MEMORANDUM

To: Salt Lake City Historic Landmark Commission

Date: May 3, 2018

Re: Liberty Square Apartments PLNHLC2017-00266 & PLNHLC2015-00237

COWBOY PARTNERS
LIBERTY SQUARE

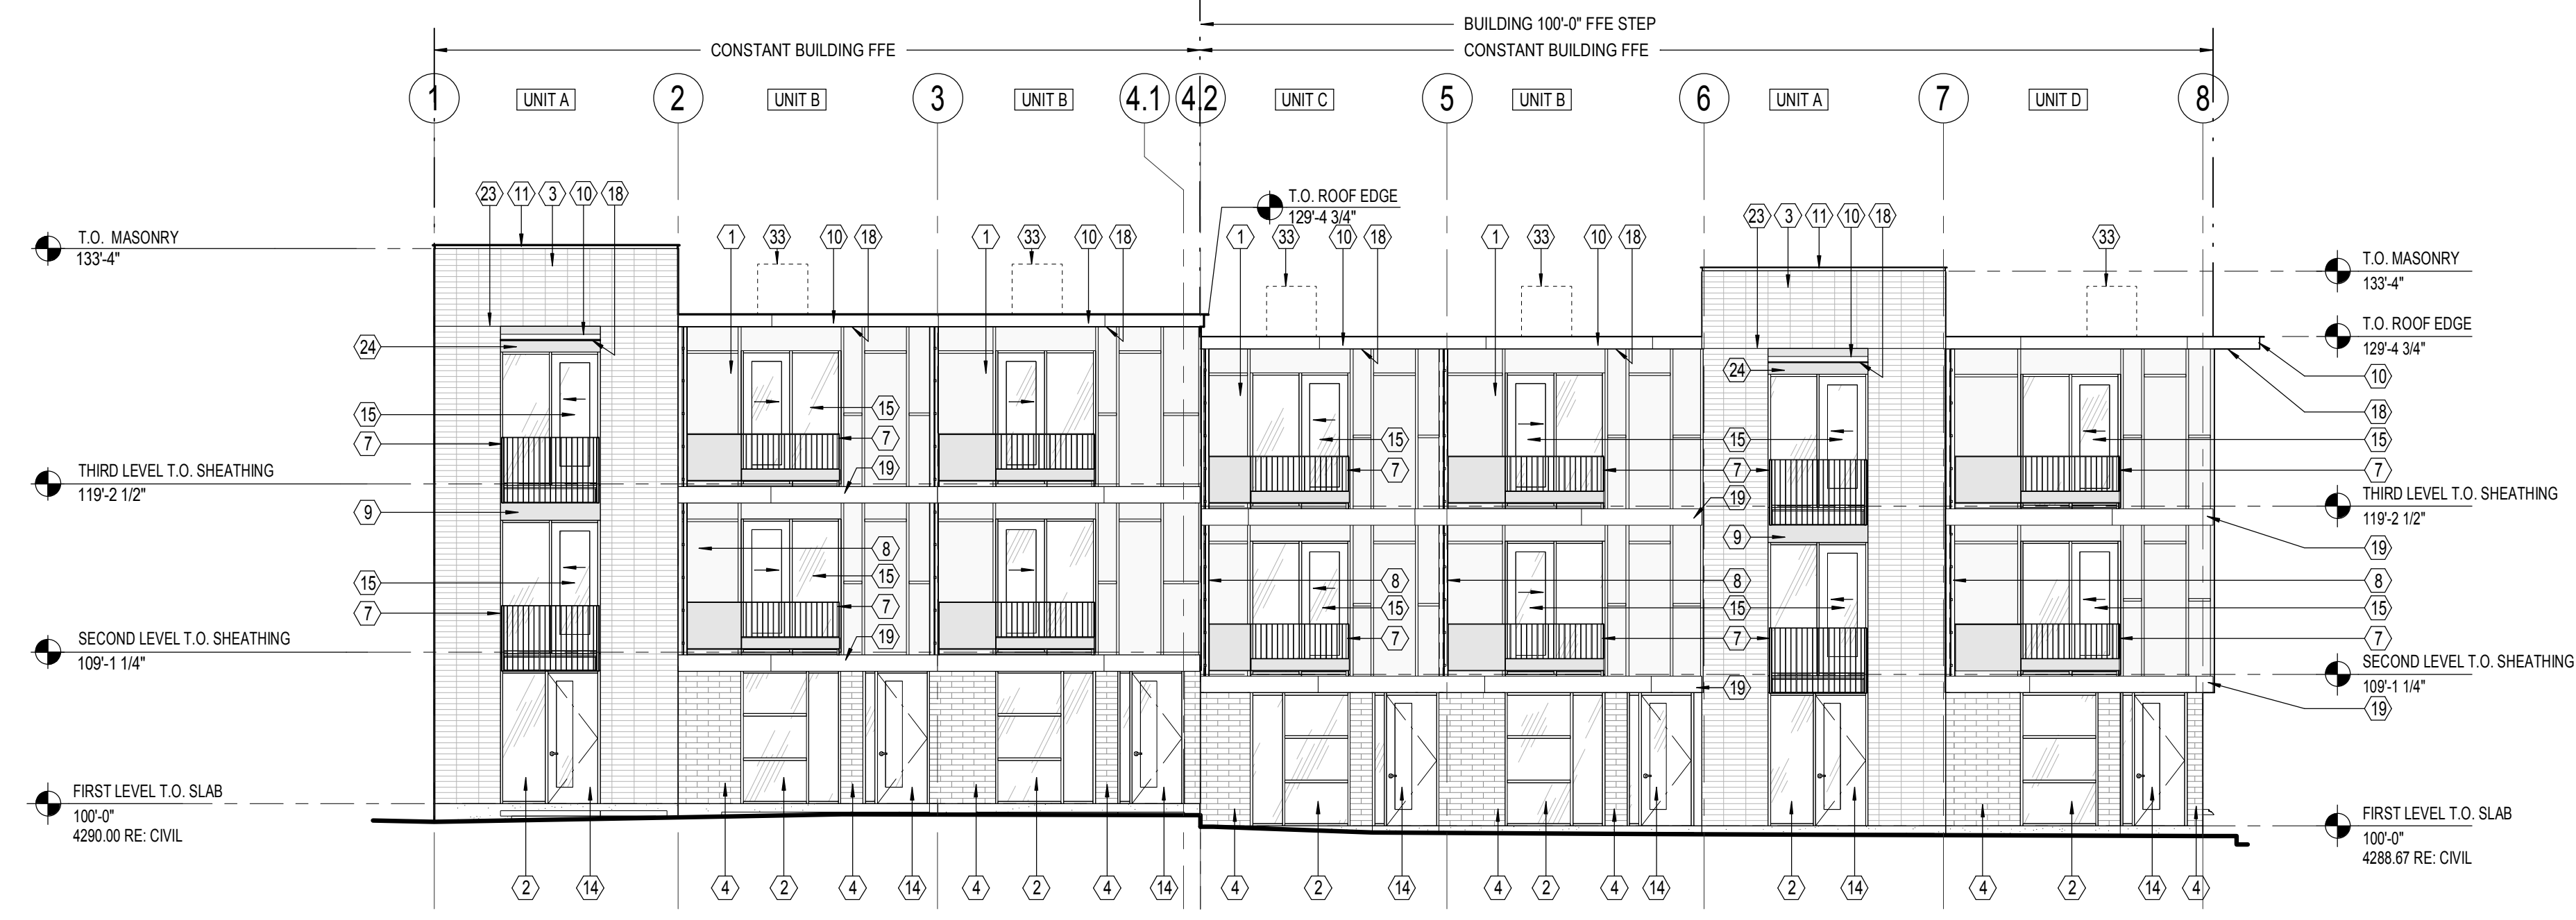
The cedar soffit has been revised to a metal soffit to match the fascia, which emphasizes the strong horizontality of the projected eaves. Refer to the attached Exterior Elevations for Buildings 1 – 8 drawings A2.1 – A2.5.

The "roof feature" at the corner eave on the east elevation of Building 1 in the June 2017 HLC submittal provided latticed openings on the edge of the roof eave that obscured any visual reference to the development signage above, particularly from street level. In effort to provide visual reference to the development signage and better articulate the development's corner presence on 500 South and Green Street, the current design proposal includes latticed openings within the roof plane that actually allow the signage and daylighting to continue down the face of the building accentuating the clubhouse entrance and building corner.

SHEET NO. A2.6

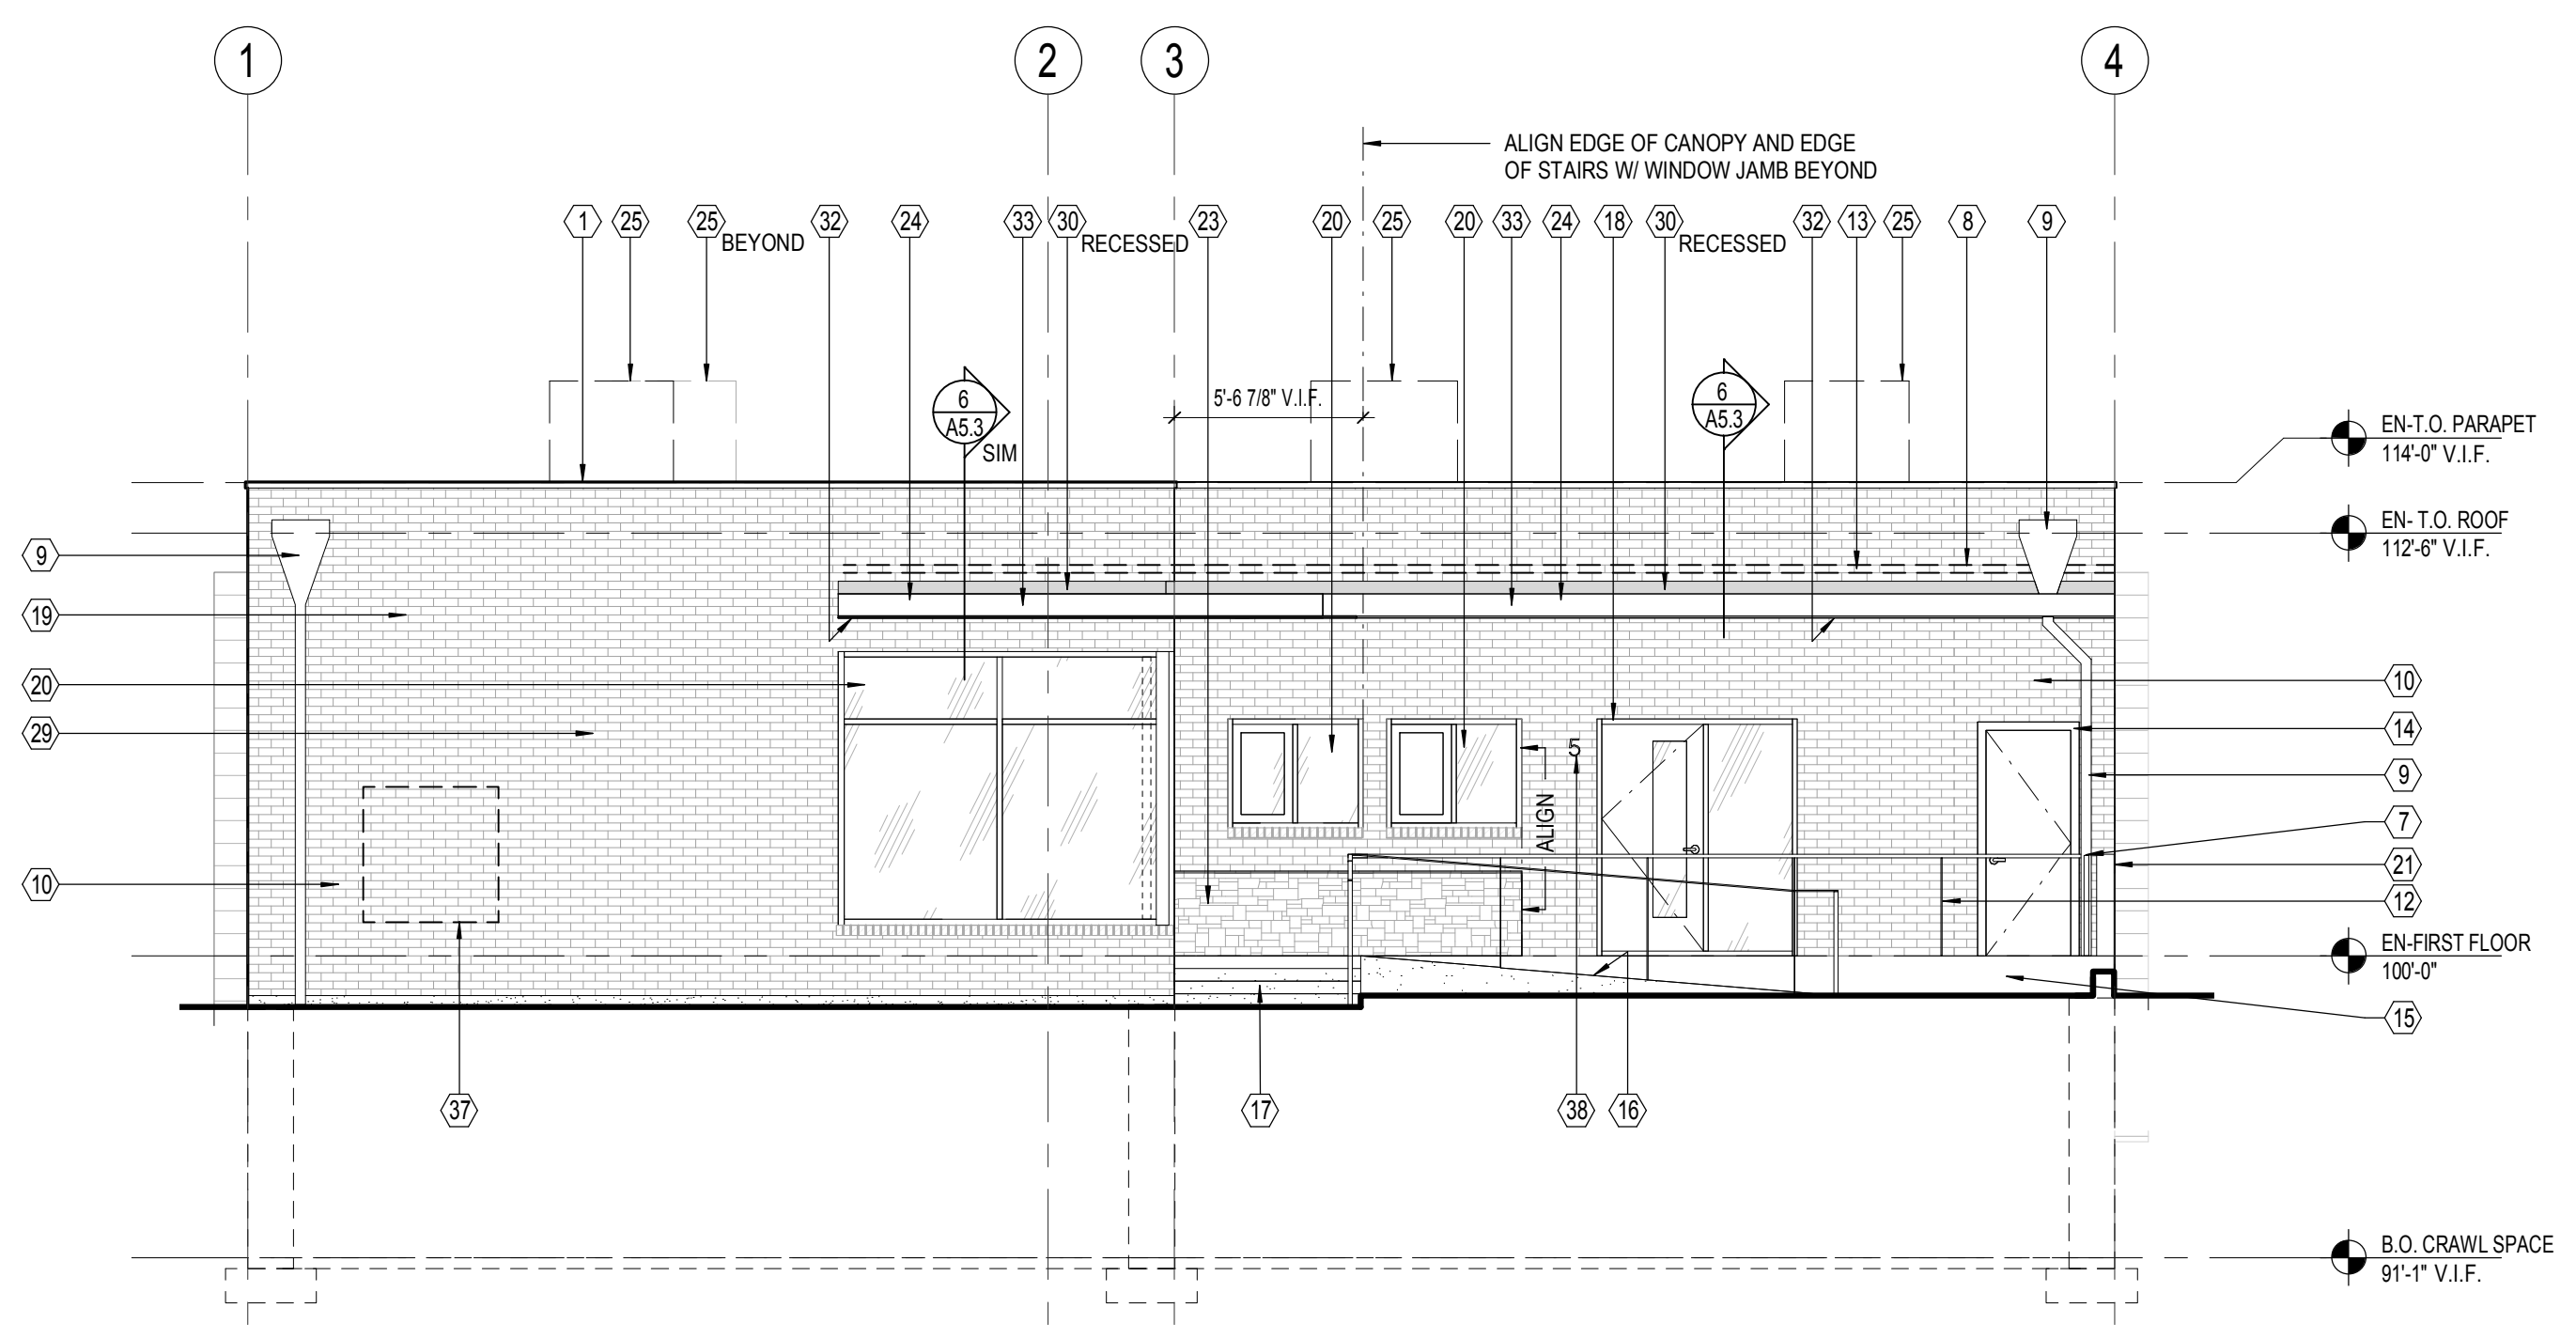
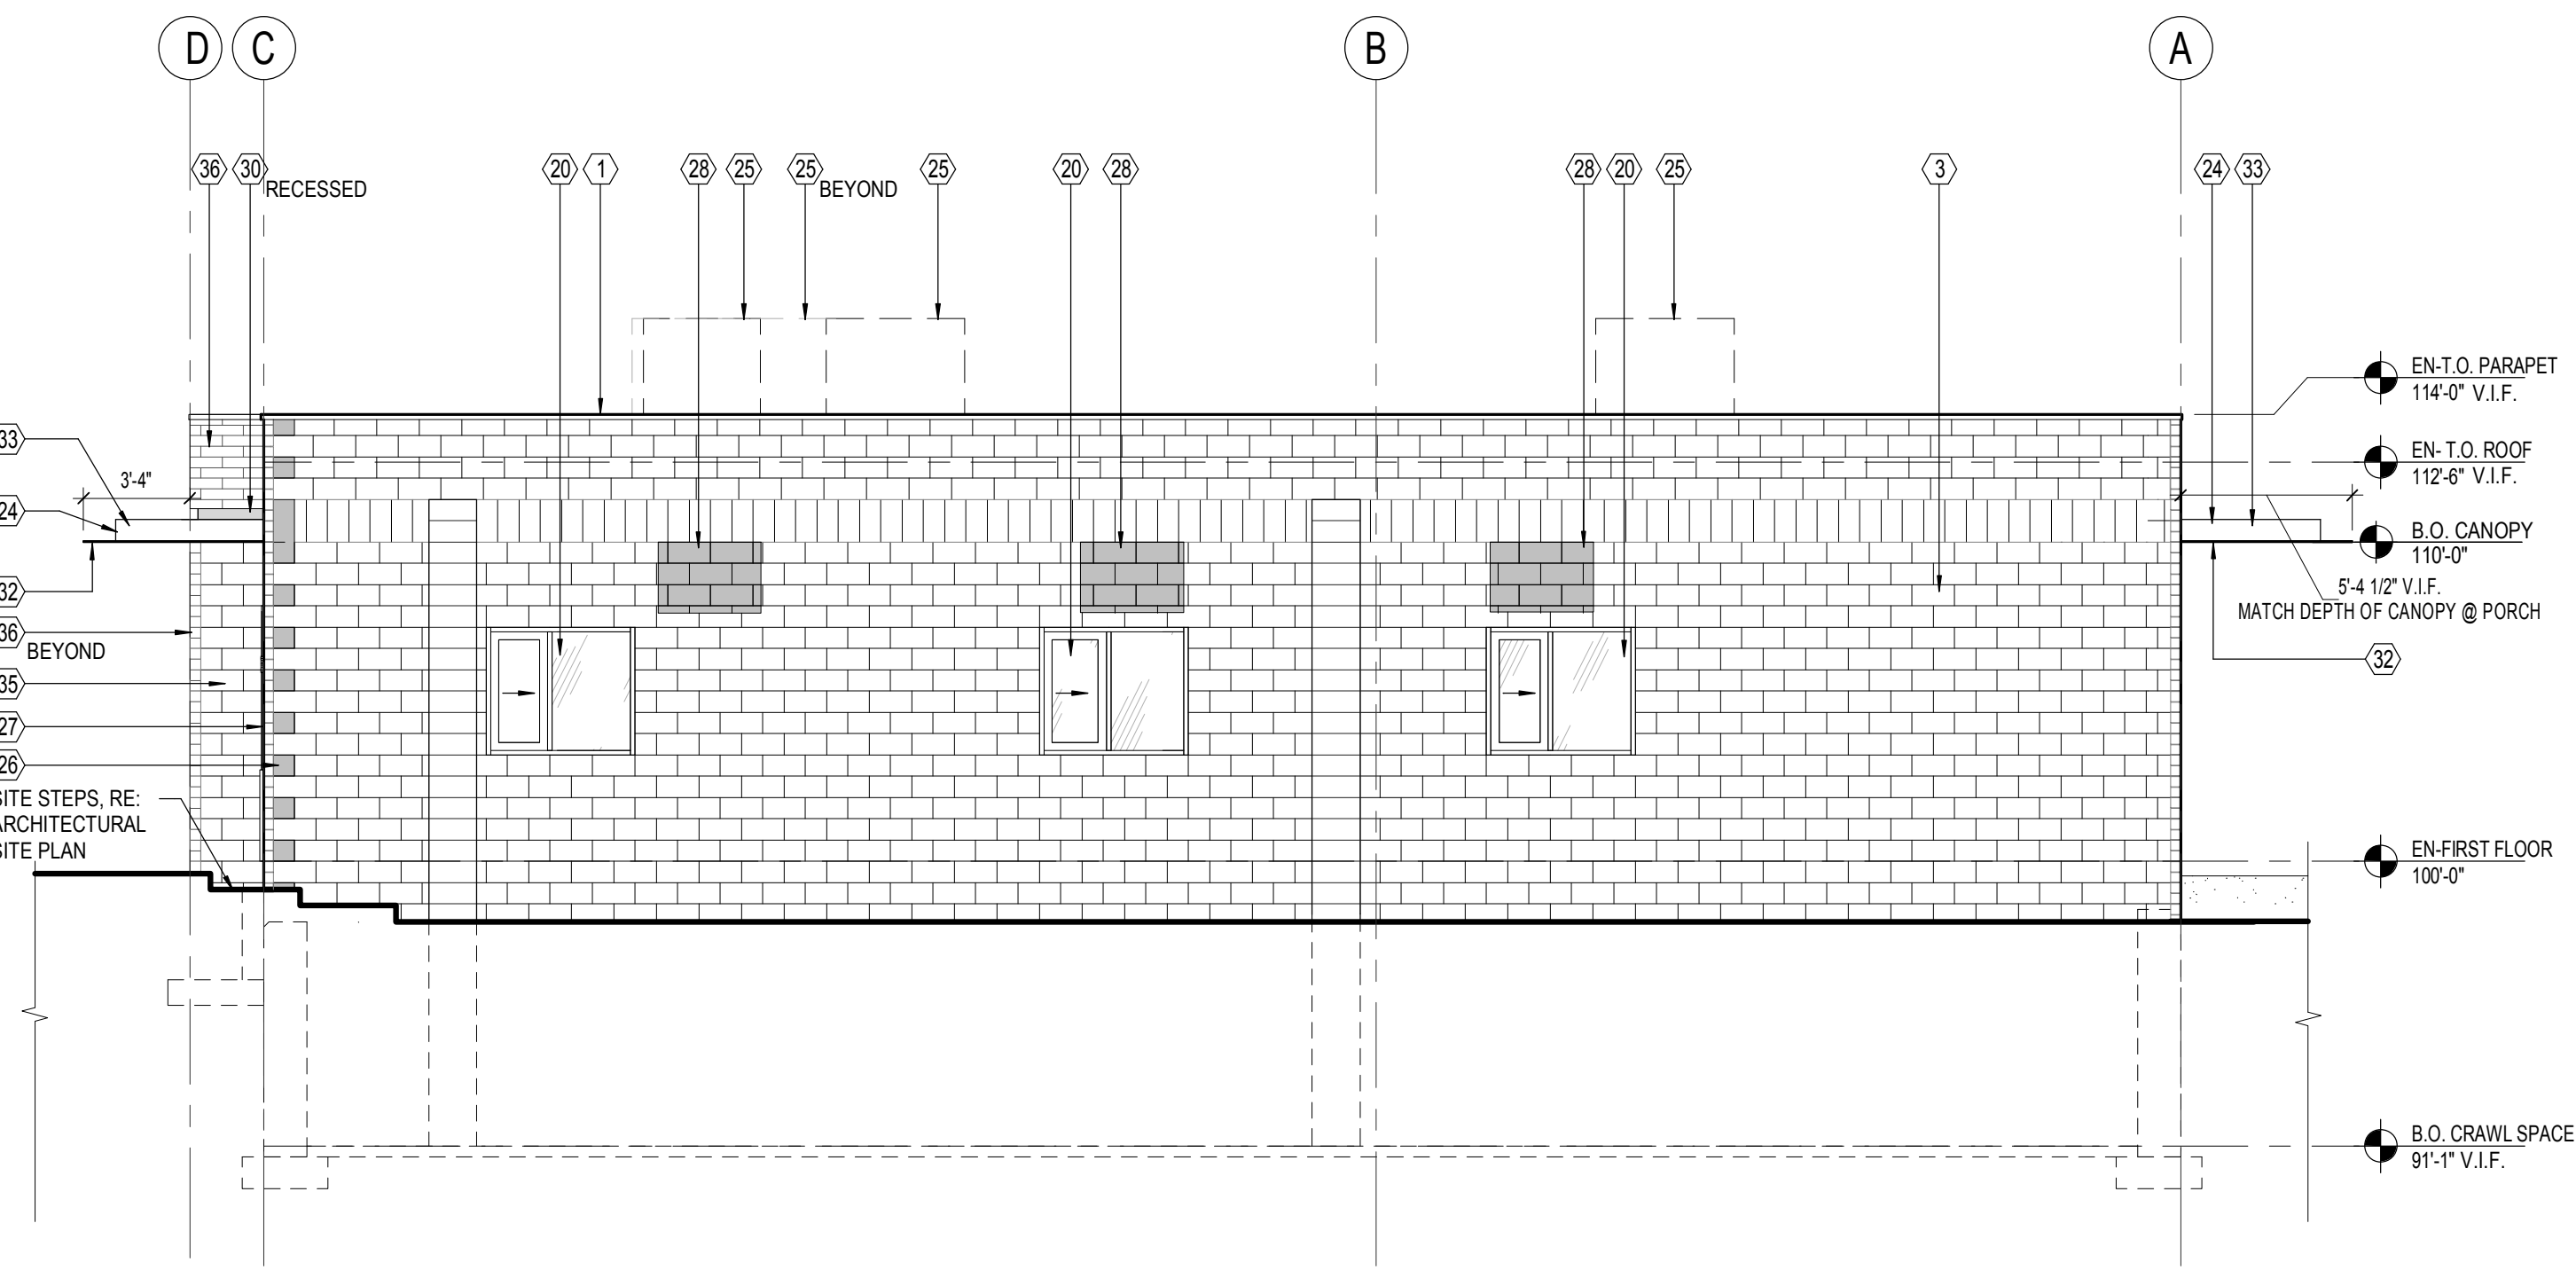
General Comments – A majority of the changes in the façades of the Ensign Building have been precipitated from further development of the unit configurations. The building reference plan has been included as an attachment for reference. The building and site improvements have been designed to accommodate ADA Access throughout, thereby requiring relocation of exterior doors and windows to comply with ADA access and emergency egress requirements. Refer to the attached Ensign Building Reference Plan drawing A1.8, Ensign Building Exterior Elevations drawing A2.6 and ICC A117.1-2009 section 403.5.

- a. The planter box is proposed to be removed and reconstructed to accommodate the required width for ADA access into the building's southern unit while preserving the depth of the porch.
- b. An accessible ramp has been included to provide accessible access to the residential units.
- c. The stairs and porch are proposed to be reconstructed to accommodate the new ramp and code required landing area at the building's main entry.
- d. The entry into the building's southern unit are proposed to be provided with a single door with sidelights to accommodate greater security for the residents.

- e. An additional door has been added to the south side of the west elevation to accommodate the required fire riser room.
- f. Signage – Signage will be addressed as a deferred submittal.

- a. The June 2017 HLC submittal shows an approximately 5-foot 6-inch entry door which does not satisfy code requirements. The mullions and door have been revised to allow for a 6-foot 10-inch entry door to align with the existing opening on the west façade.
- b. As part of the porch replacement, the south end of the porch has been extended up to serve as a screen wall from the neighboring gas station and as a guard rail as required per the building code at this location.

- a. Windows have been located and sized as required to maintain the code required operable function for egress from the interior units.
- b. The widths of the windows are limited in area so as not to trigger a seismic upgrade to the building. The current size is within the code required 10% maximum allowable modification to the existing structural lateral resistance system.
- c. The existing masonry on this façade is proposed to be painted to match the existing south façade.
